From: Philip Barrett
Sent: 7 Jan 2020 08:04:58 +1300
To: Cameron Aplin
Subject: G & S Singleton- Section 92 reply Updated and final SW Mgt Plan
Attachments: L2 Stormwater Management Plan - 635 Whatwhata Road, Hamilton Full and Final.pdf

Stormwater Management Plan

*M13246AP2
20 December 2019*

Westlands Subdivision Response to Beca Review

Figure 3.4 – Hydrographs to show attenuation of peak flows

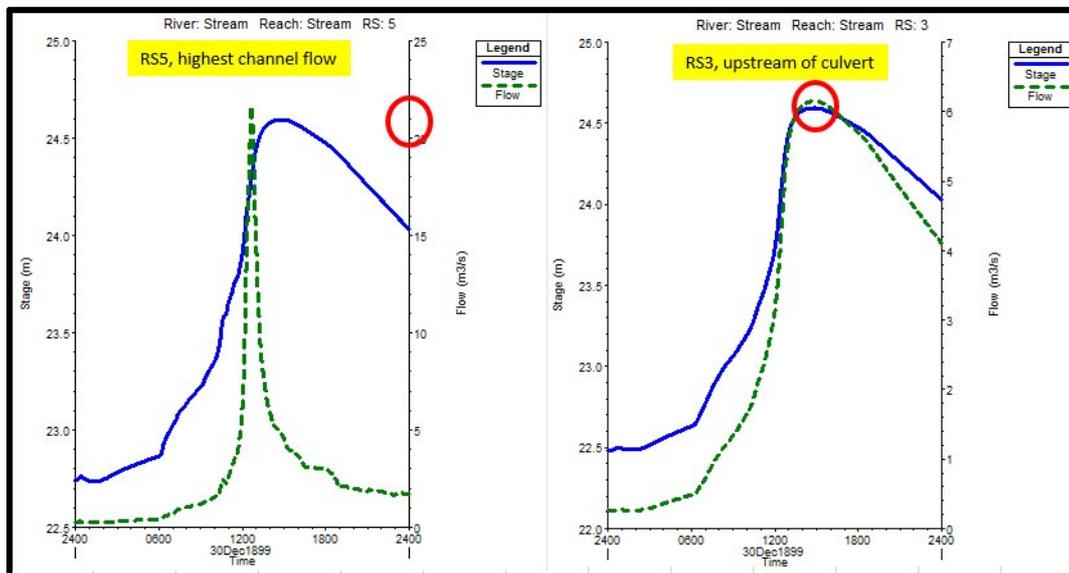
13	Section 3.2 first paragraph –wording is unclear. Please revise	This has been remedied
14	The downstream boundary location is not show on map. Please show and clarify this is sufficiently far enough downstream i.e. there are no further controls downstream that could influence the culvert performance.	This has been remedied. Site inspection shows that downstream controls will be irrelevant. A Normal slope is fine and is shown by the HGL to fine due to the upstream flood levels.
15	Downstream boundary slope is set at 0.1%. Please clarify how this was calculated and applied to the model. Figure 3.3 shows what appears to be a much steeper slope of 0.42. Downstream contours used to calculate a slope over 540m found it to be 0.007 (0.7%).	This has been remedied. See Section 3.2.
16	Figure 3.4/3.5 please update. The legend/labels to state 10yr and 100yr flows/HGL are shown but are not in the figure. Figure 3.4 are not HGL plots.	These have been remedied

Figure 4.1 – Hydraulic grade-line comparing a 50% blockage

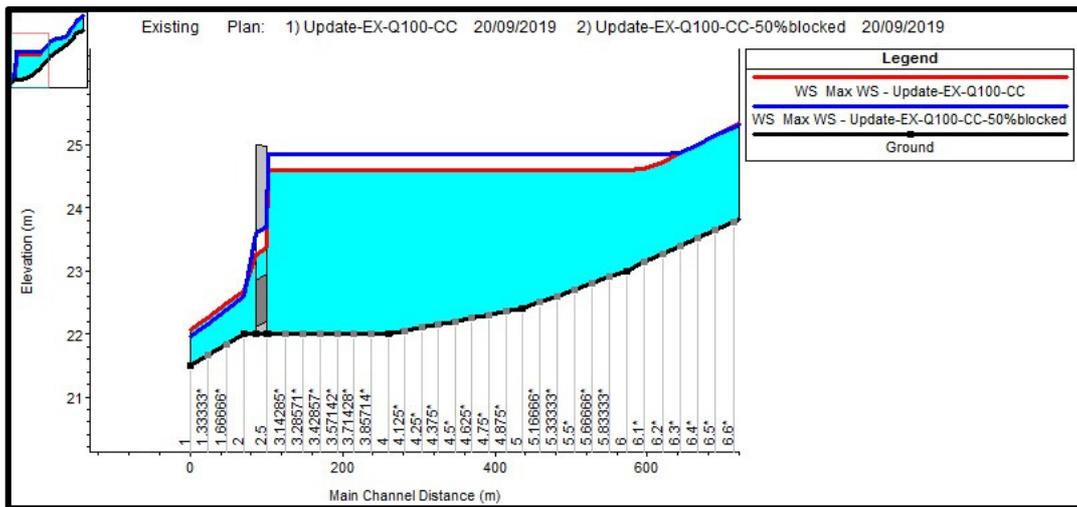
Figure 4.1 shows the hydraulic profiles along the reach comparing the non-blocked and 50% blocked. The 50% blockage effects cross-sections just upstream of RS6. The increase in water level at the culvert is 0.2m. The flow is decreased from $6.2\text{m}^3/\text{s}$ to $3.6\text{m}^3/\text{s}$.

Figure 4.2 – Change in floodplain width for 50% blockage near the culvert

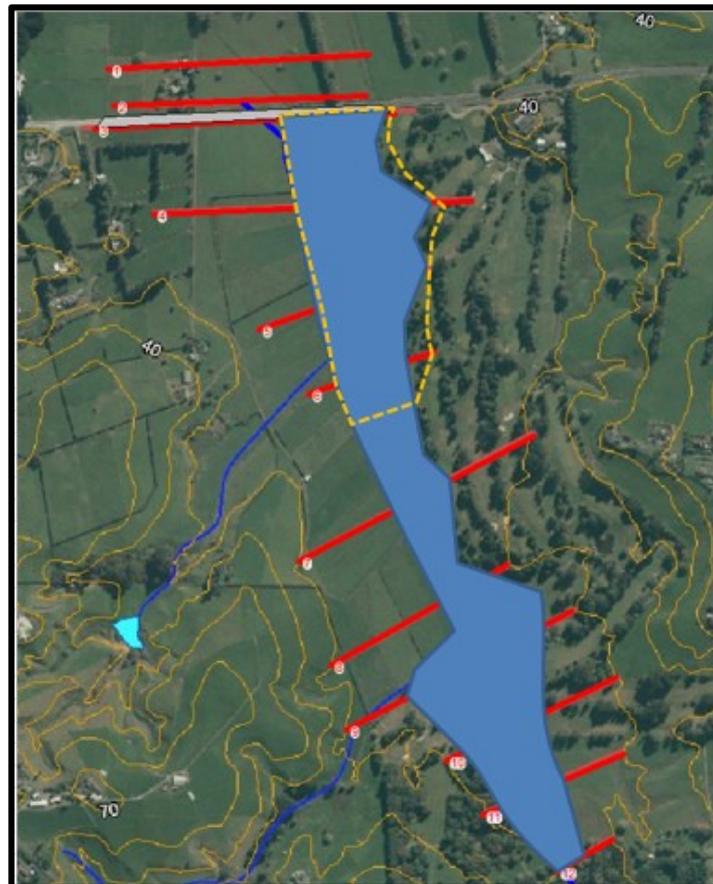
Figure 4.2 shows the floodplain for the 100-year event and the impact of the 50% blockage shown with a dashed line. The extra aerial extent is perhaps no greater than 10%.

Figure 2 – Lot 7 raised driveway HGL

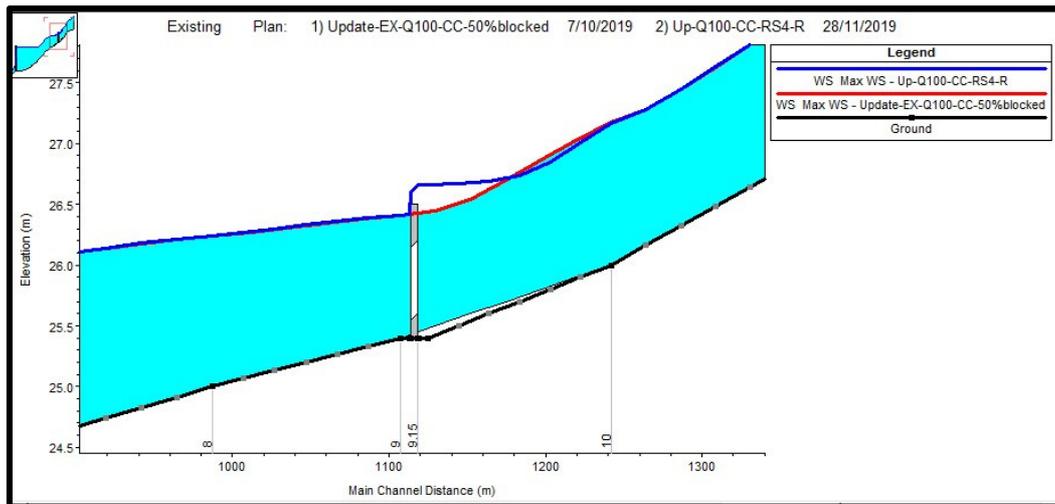
For Lot 7 the driveway cuts across overland flows. The ground level is about RL26m and the flood level is RL26.4m. This suggests a 400mm raising of the driveway. This may have an impact for the neighbours at Lot 39 DPS 76270 and Lot 1 12807. RS9 was adjusted by inserting a nominal 600mm culvert and driveway at RL26.5m. Figure 2 shows the change in HGL. Although the water level rises to get over the driveway the influence at RS10 diminishes to zero. This location is the neighbouring upstream boundary.

In conclusion, raising the roadway in Lot 10 requires the FFL of Lot 1 to be raised by 30mm. Within Lot 7 a culvert needs to be under the driveway to drain the area but its design and raised driveway does should not affect neighbouring properties.

Figure 3 – Lot 1 subcatchment

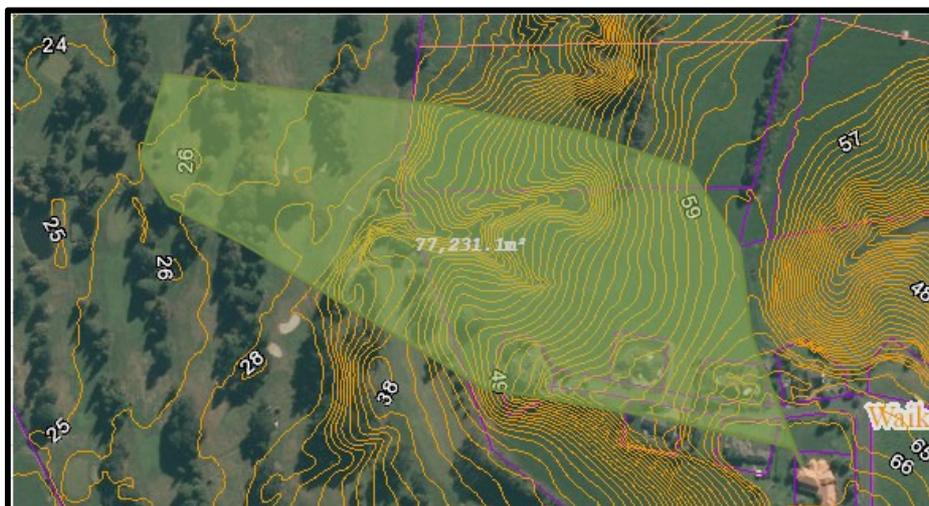
The catchments for Lots 1 and 7 were analysed. The lot 1 catchment is the largest example for houses in Lots 2, 3, 4, 5 and 10. While Lot 7 has a catchment size based on the adjacent drain. These are shown in Figures 3 and 4.

At Lot 1 if the flow width is 24m or more the depth of flow is less than 100mm. For Lot 7 it is 23m. Close examination of the ground profiles there is no concentration of flows but general sheet flow. The widths of the Lots are about 40-50m and therefore the flow depths will be less than 100mm and the allowance for OLFP is within the normal building regulations for ground clearance.
